Amendments to the Drawings:

REMARKS / ARGUMENTS

Appl. No. 10/712,153
Amdt. dated 03/28/2006
Reply to Office action of 09/28/2005

FIG. 1A

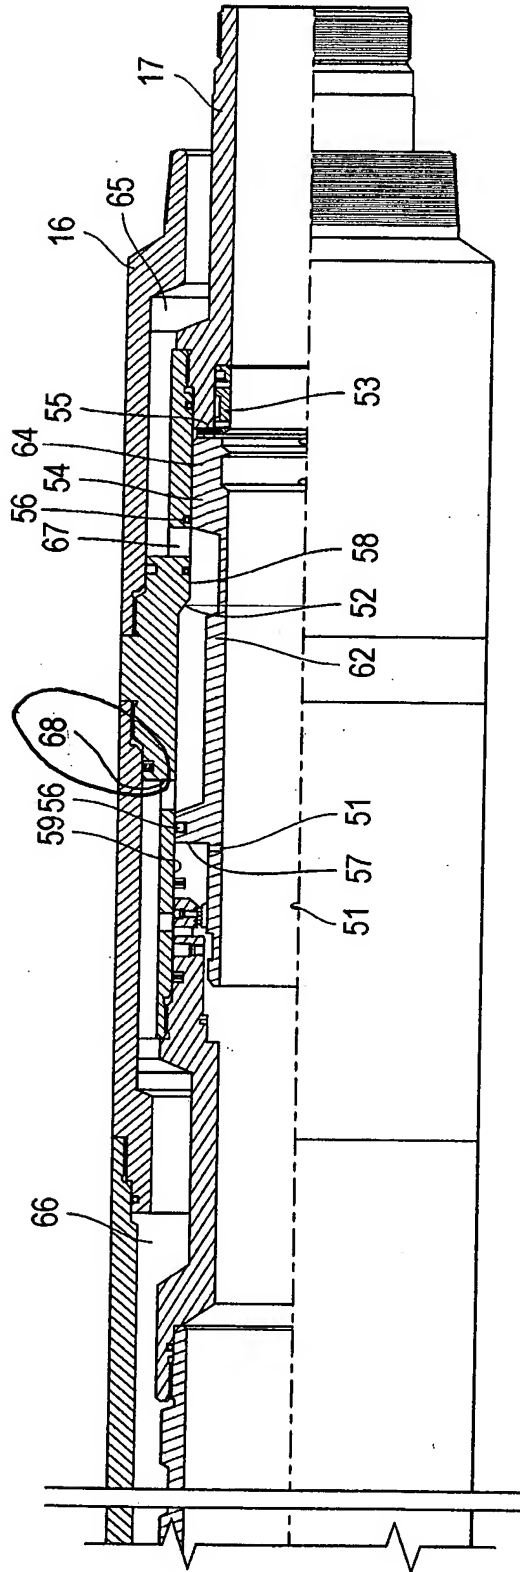
1. On sheet 1/46 in Figure 1A, reference number 68 has been added. Support may be found in paragraph [0057].
2. On sheet 7/46 in Figure 3A, reference numbers 311 and 322 have been added. Support may be found in paragraphs [0062] and [0063].

3. The drawings are objected to as failing to comply with 37 CFR 1.84(p)(5) because they do not include the following reference character(s) mentioned in the description: 68, 311, 322, and 710.

Reference number 68 has been added to Figure 1A, and reference numbers 311 and 322 have been added to Figure 3A. No new matter has been added. Applicant was unable to find reference number 710 in the subject specification.

FIG. 6C

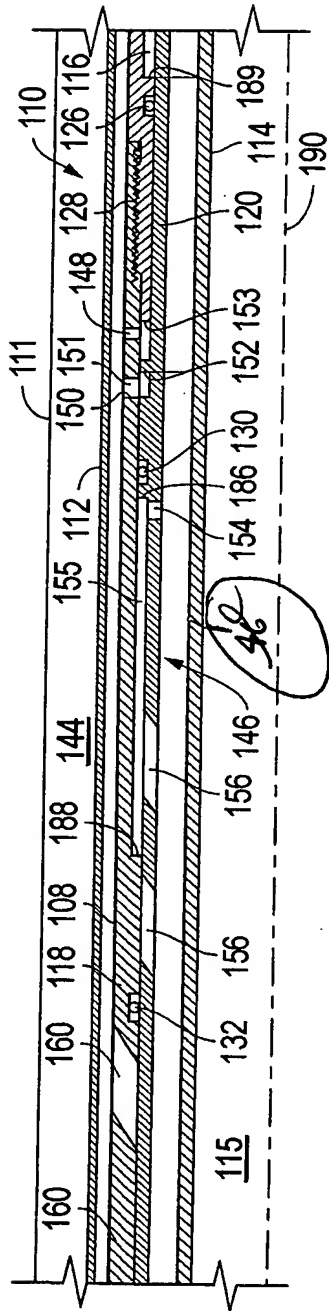
3. On sheet 12/46 in Figure 6C, reference number 46 has been deleted.
4. On sheet 18/46 in Figures 12A, 13A and 14A, reference number 800 has been added. Support may be found in paragraphs [0086] through [0091].

2. The drawings are objected to because reference character "46" in Figure 6(c) should be deleted and because Figures 12A-16A, 12B, 14B-16B, 15C, 16C, 12D, 14D-16D, and 13E do not contain reference numbers which the examiner considers essential to the understanding of the claimed invention. Applicant is reminded that any reference numbers added to the above figures should be within or added to the specification.

Reference 46 has been deleted from Figure 6C. Figures 12A through 12E, 13A through 13E, 14A through 14E, 15A through 15E and 16A through 16E have been amended by adding one or more reference numerals to place the figure in the context of the existing specification. No new matter has been added.

FIG. 12B

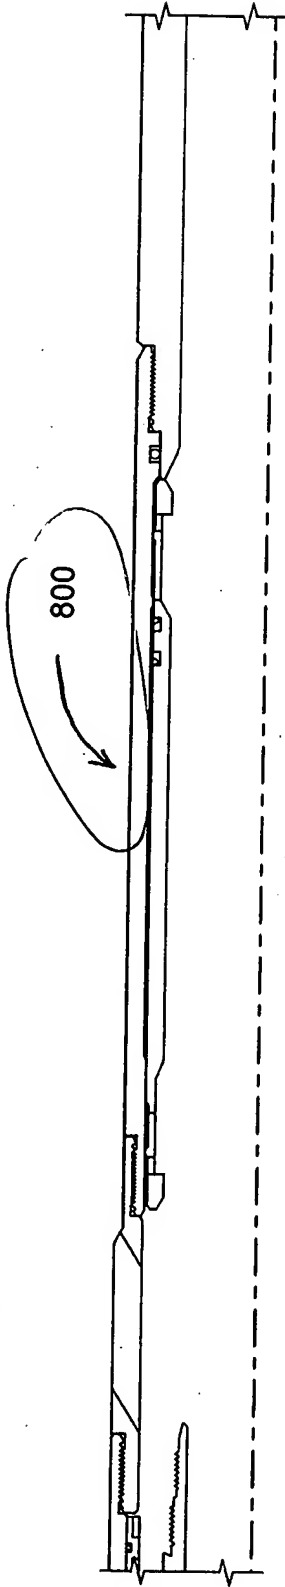
5. On sheet 19/46 in Figures 15A and 16A, reference number 800 has been added. Support may be found in paragraphs [0086] through [0091].
6. On sheet 20/46 in Figures 12B, 13B and 14B, reference number 800 has been added. Support may be found in paragraphs [0086] through [0091].

FIG. 15B

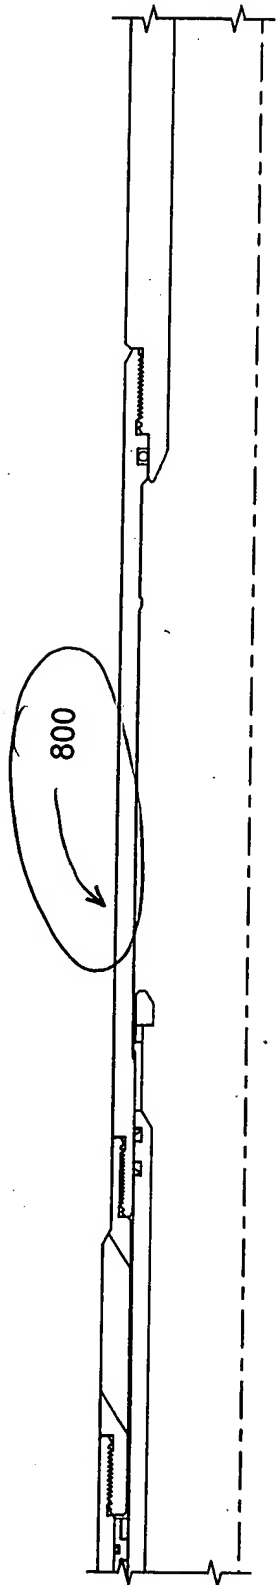
7. On sheet 21/46 in Figures 15B, 16B, reference number 800 has been added. Support may be found in paragraphs [0086] through [0091].
8. On sheet 22/46 in Figures 12B, 13B and 14B, reference number 800 has been added. Support may be found in paragraphs [0086] through [0091].

FIG. 15C

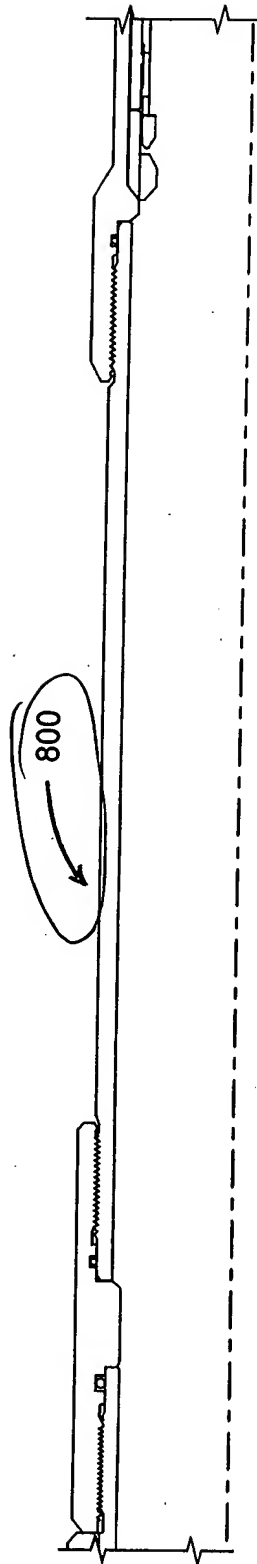
9. On sheet 23/46 in Figures 15C, 16C, reference number 800 has been added. Support may be found in paragraphs [0086] through [0091].
10. On sheet 24/46 in Figures 12D, 13D and 14D, reference number 800 has been added. Support may be found in paragraphs [0086] through [0091].

FIG. 15D

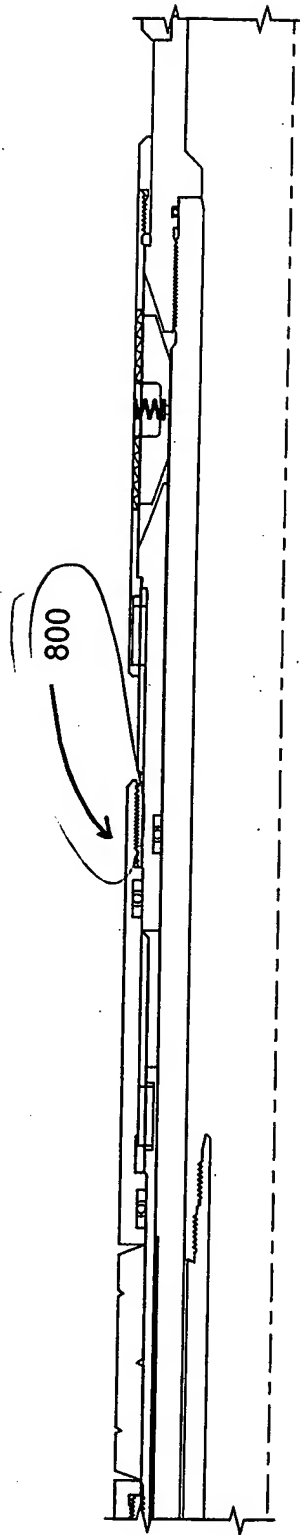
11. On sheet 25/46 in Figures 15D, 16D, reference number 800 has been added. Support may be found in paragraphs [0086] through [0091].
12. On sheet 26/46 in Figures 12E, 13E and 14E, reference numbers 800 and 835 have been added. Support may be found in paragraphs [0086] through [0091].
13. On sheet 27/46 in Figures 15E, 16E, reference number 800 has been added. Support may be found in paragraphs [0086] through [0091].
